CITY OF TEMPE DEVELOPMENT REVIEW COMMISSION

Meeting Date: 10/28/2014 Agenda Item: 4

ACTION: Request for an Amended Planned Area Development Overlay, a Use Permit to allow tandem parking, and a Development Plan Review consisting of a new 258 unit apartment development for JEFFERSON TOWN LAKE, located at 909 East Playa del Norte. The applicant is Huellmantel & Affiliates.

Revised gate location plan

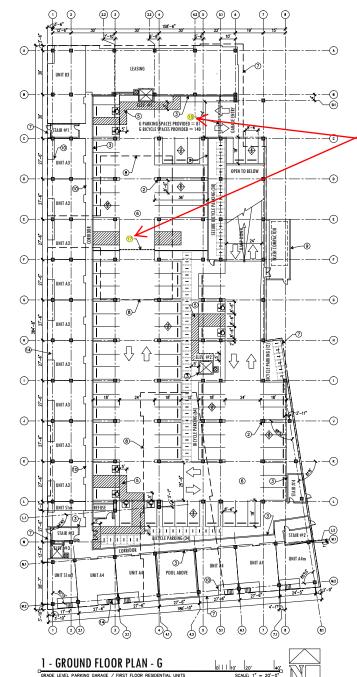
- f. For lack of driver visibility, the parking space to the southwest of the up/down ramp shown on the preliminary gate location plan (floor level G) is not approved. Relocate this parking space and provide a minimum 10-foot separation between the nearest parking space and the edge of the ramp.
